Attachment

Proposed Changed Pages

Unit 1

ADMINISTRATIVE CONTROLS

Figure 6.2-1 Offsite Organization for Facility Management and Technical Support

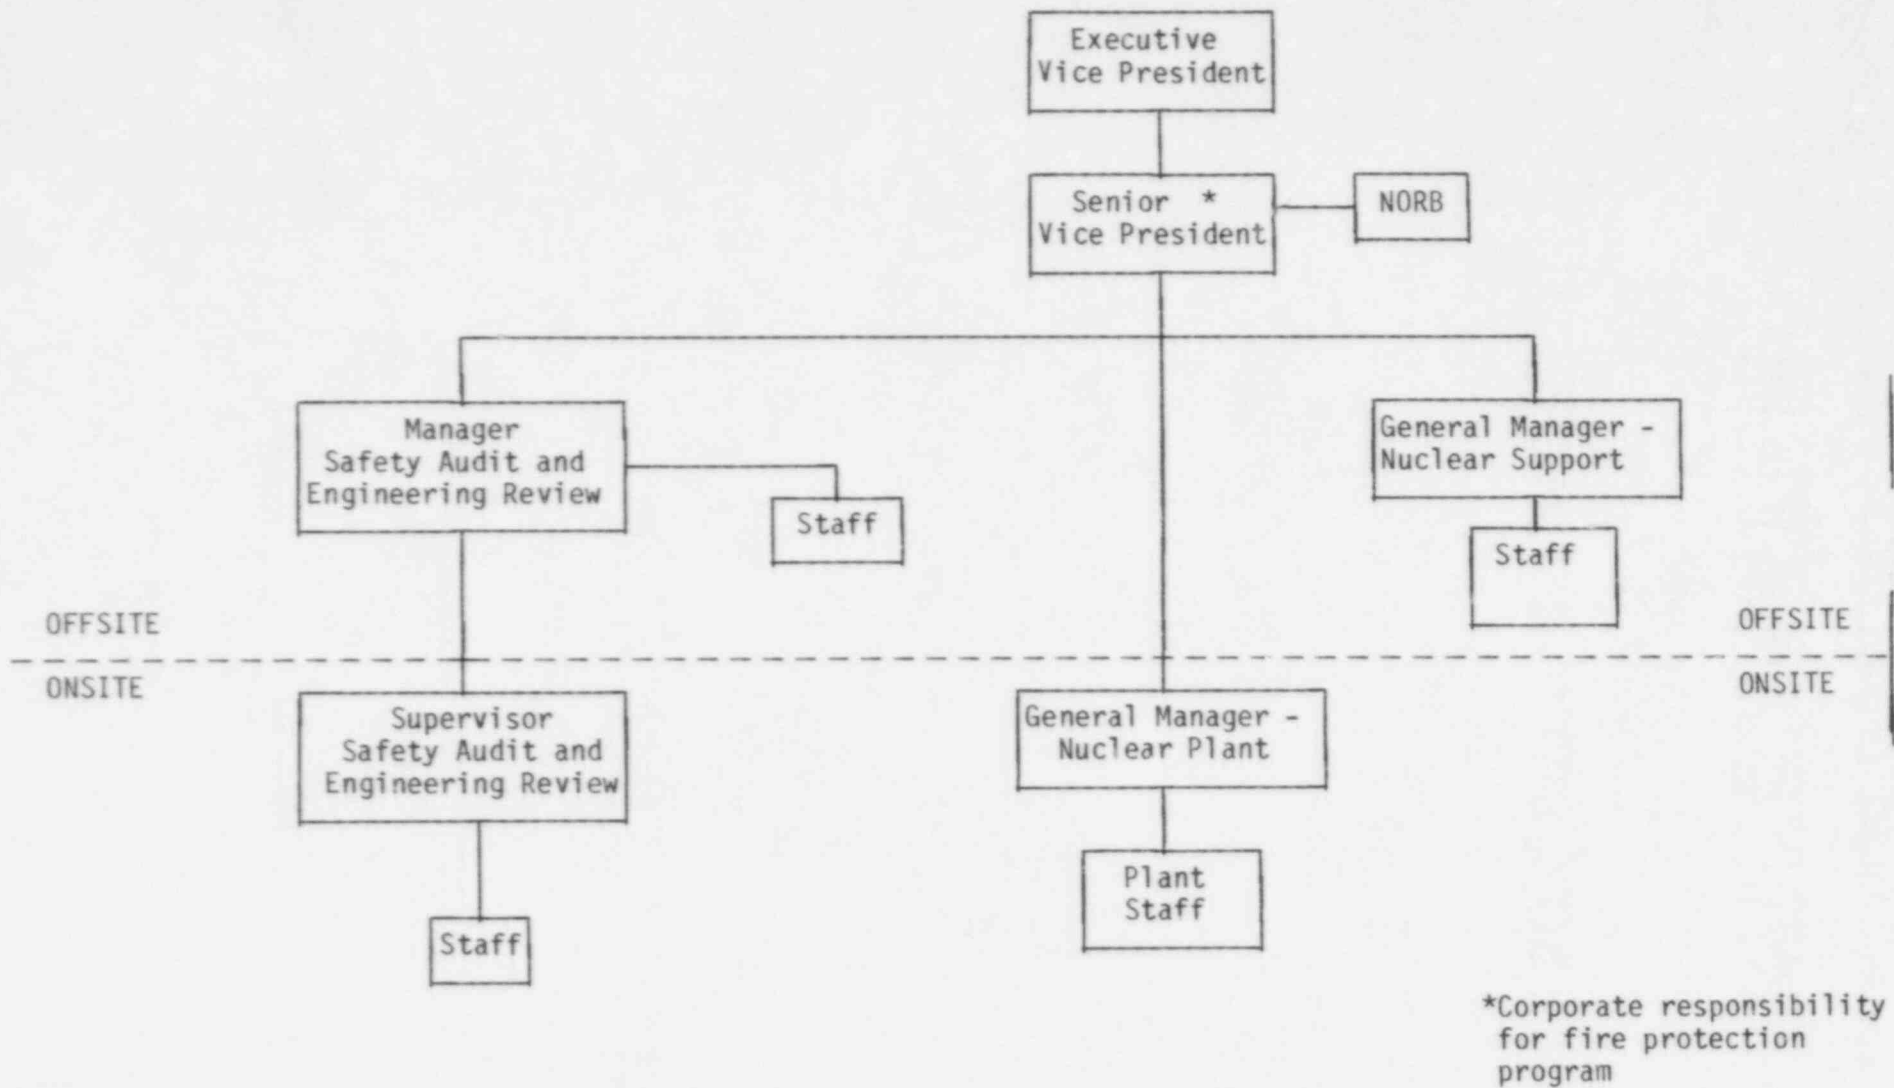
6.2.1 The offsite organization for facility management and technical support shall be as shown on Figure 6.2-1.

Figure 6.2-2 Facility Organization

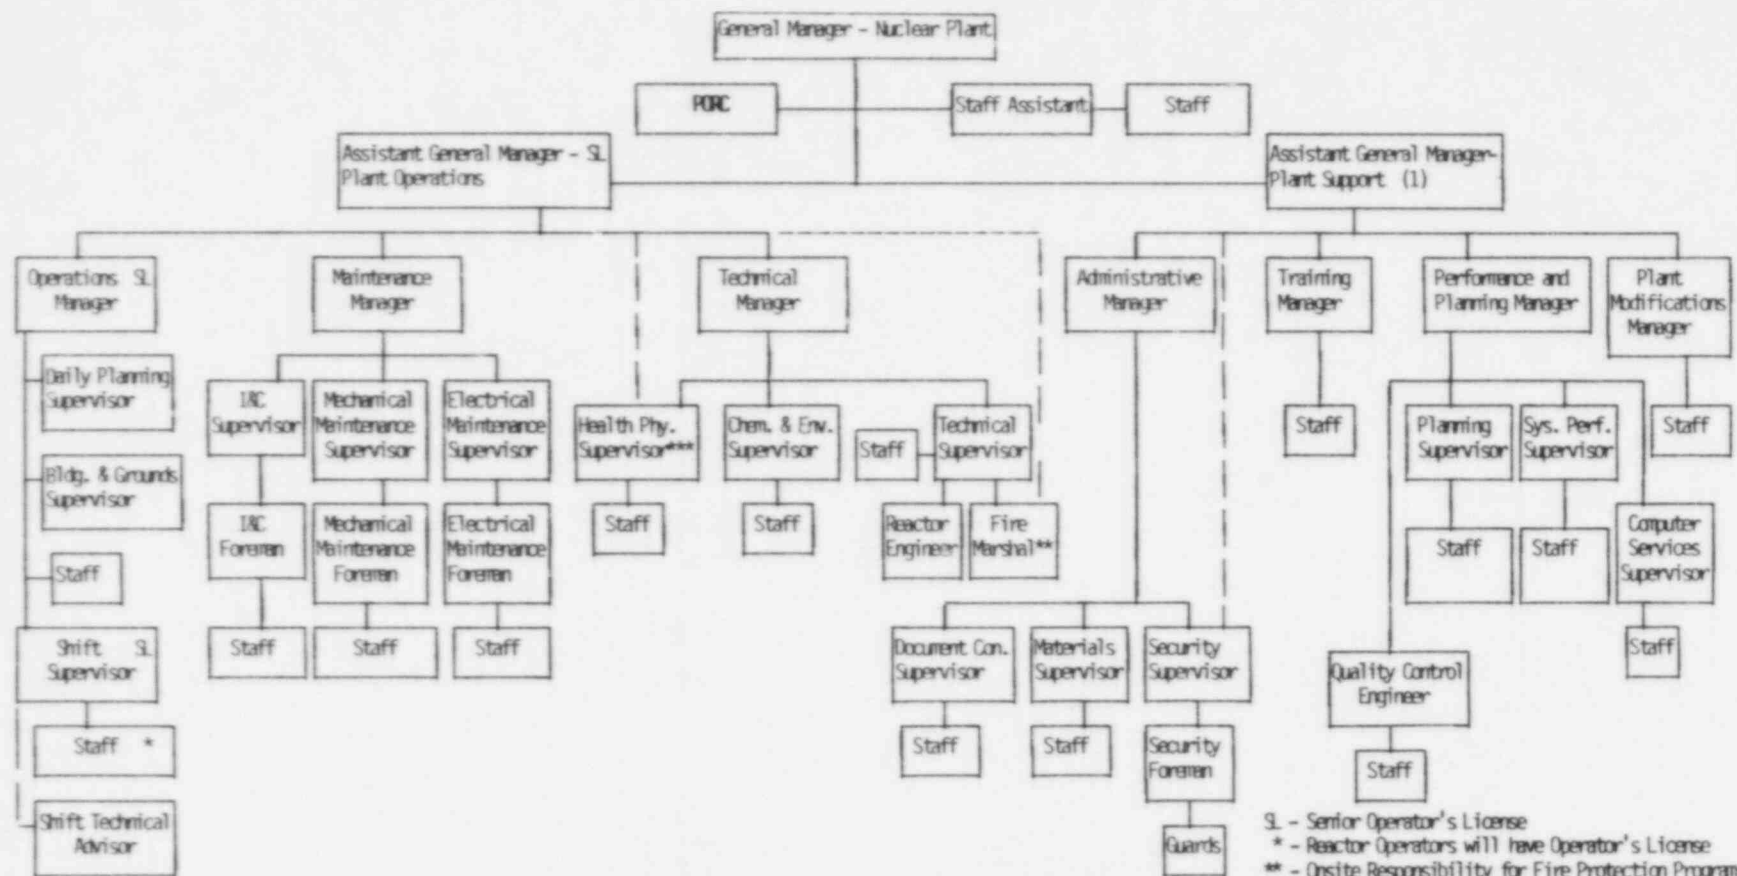
6.2.2 The facility organization shall be as shown on Figure 6.2-2 and:

*** In routine matters, the Health Physics Supervisor reports directly to the Technical Manager. In matters of radiation policy determination, interpretation or implementation (based upon the Health Physics Supervisor's judgment), the Health Physics Supervisor may report directly to the Assistant General Manager - Plant Operations.

(1) The person filling this position may act as the General Manager - Nuclear Plant, provided this person meets the requirements of ANSI N18.1-1971 Section 4.2.1, FSAR Section 13.1.3.1.1 and has completed Emergency Director Training.

Figure 6.2-1 Offsite Organization for Facility Management and Technical Support

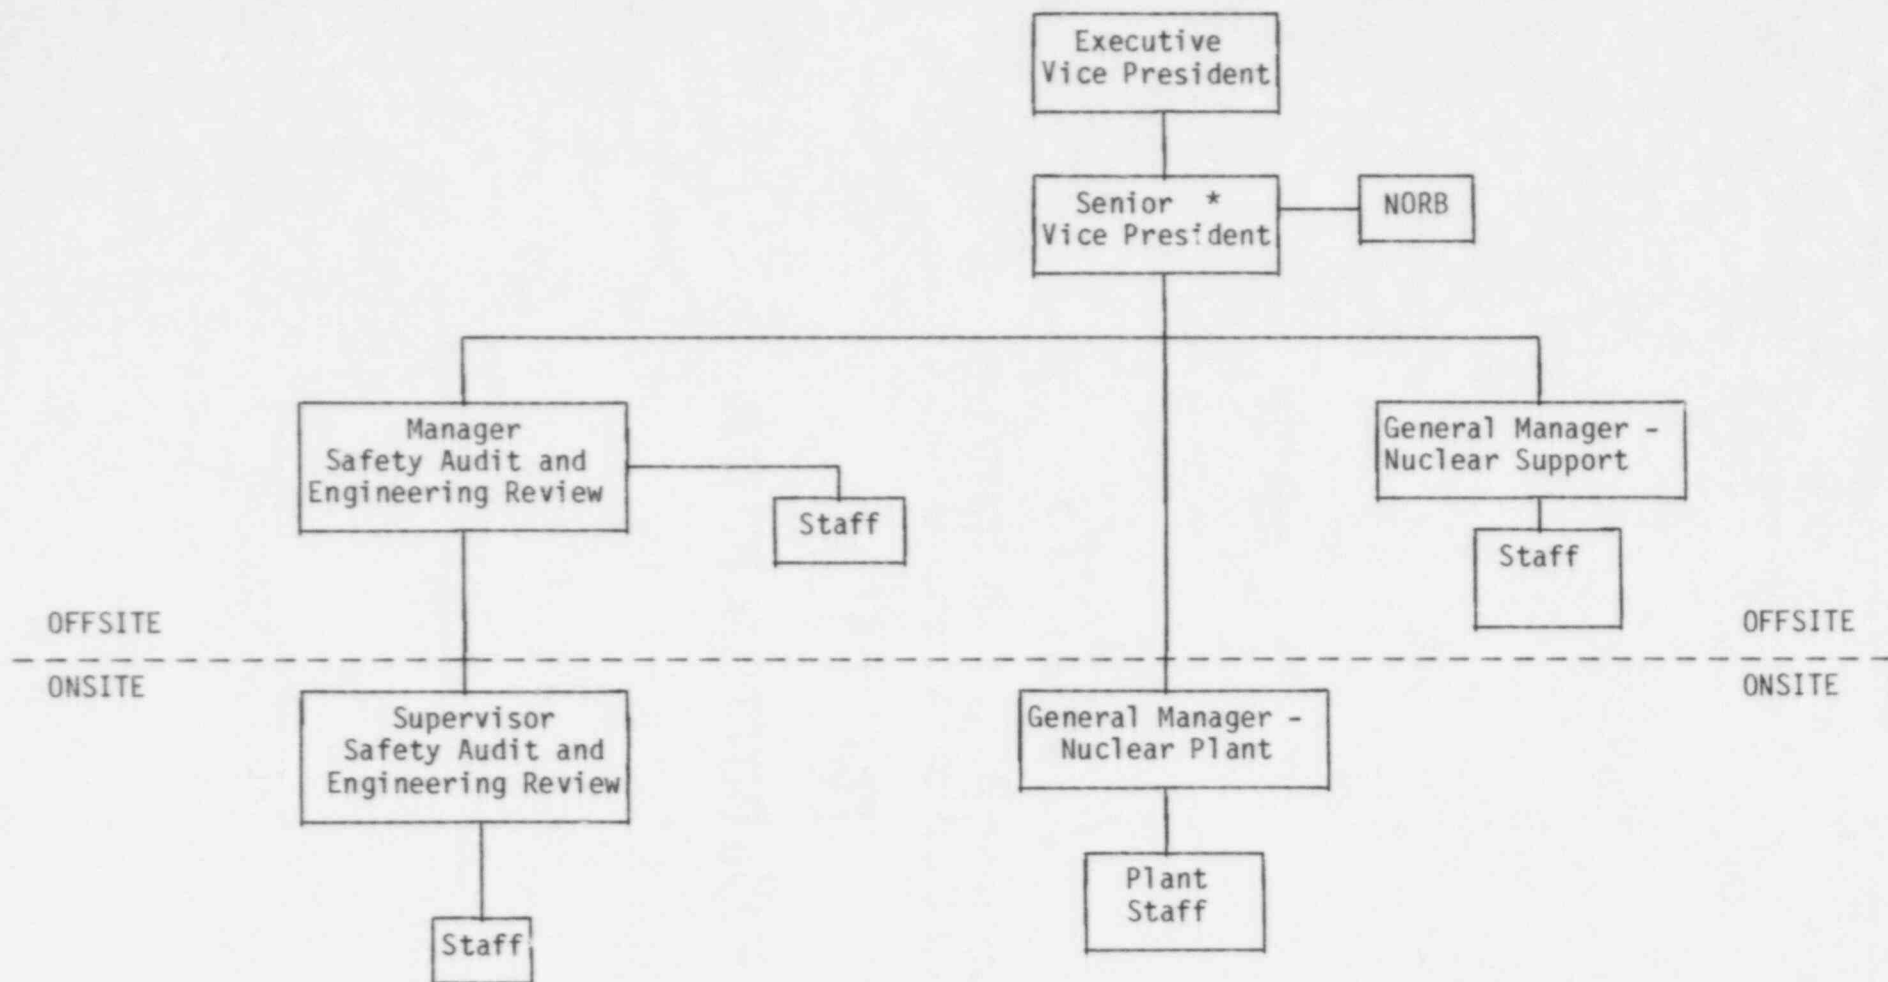
6.2.1 The offsite organization for facility management and technical support shall be as shown on Figure 6.2-1.

*Corporate responsibility for fire protection program

Figure 6.2-2 Facility Organization

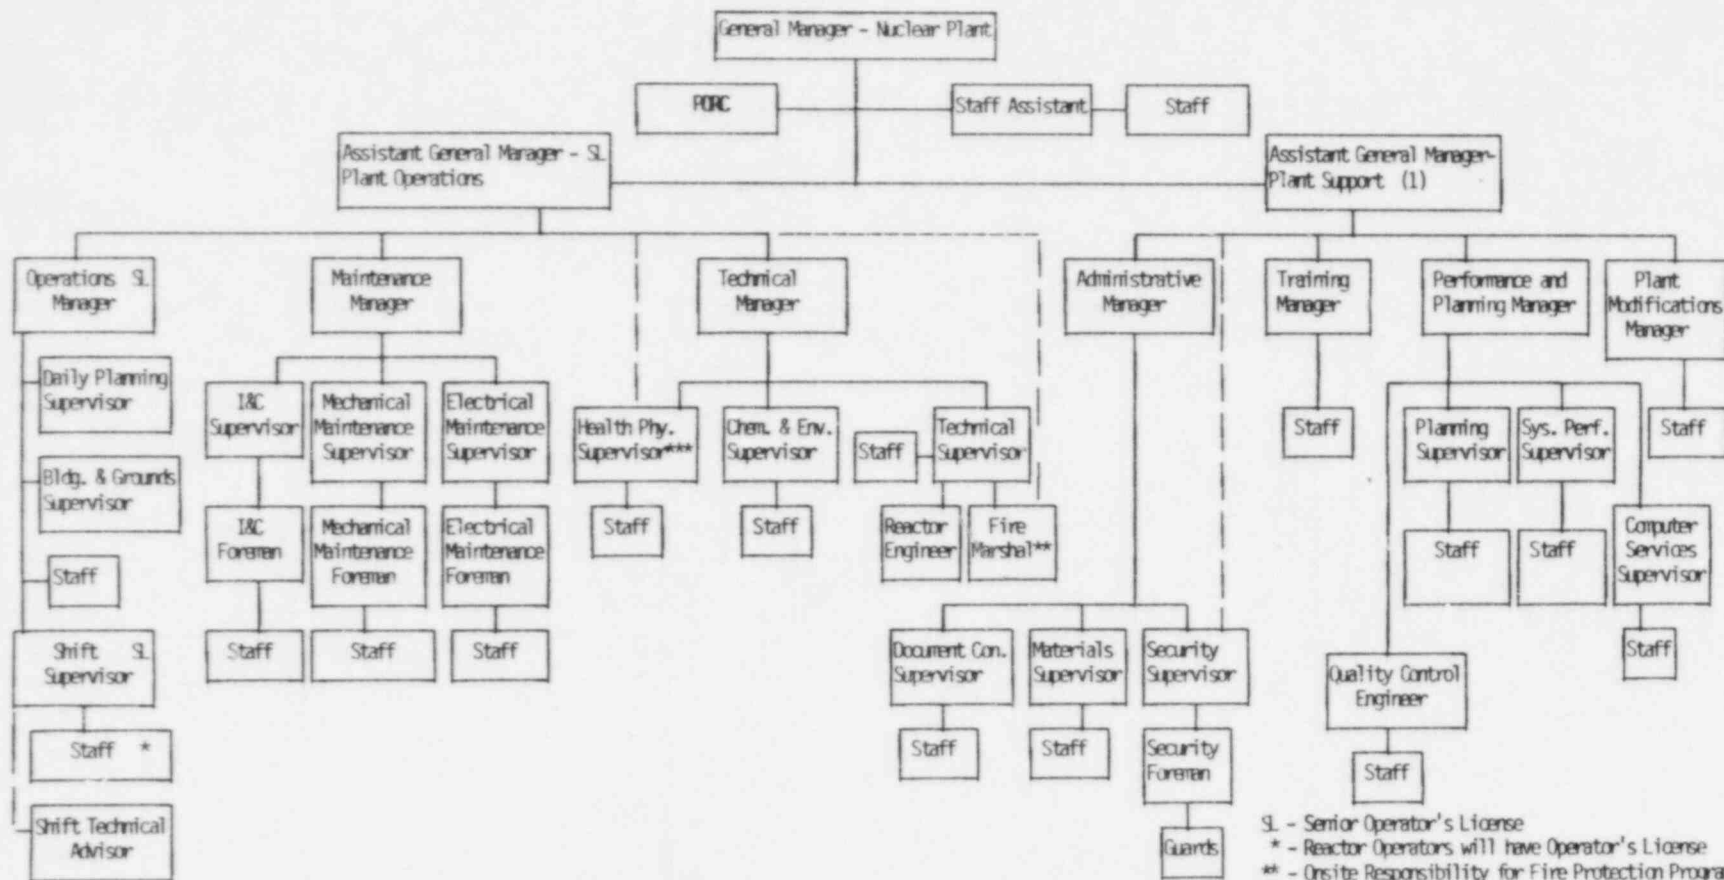
6.2.2 The facility organization shall be as shown on Figure 6.2-2 and:

*** In routine matters, the Health Physics Supervisor reports directly to the Technical Manager. In matters of radiation policy determination, interpretation or implementation (based upon the Health Physics Supervisor's judgment), the Health Physics Supervisor may report directly to the Assistant General Manager-Nuclear Operations.

(1) The person filling this position may act as the General Manager Nuclear-Plant, provided this person meets the requirements of ANSI N18.1-1971 Section 4.2.1, FSAR Section 13.1.3.1.1 and has completed Emergency Director Training.
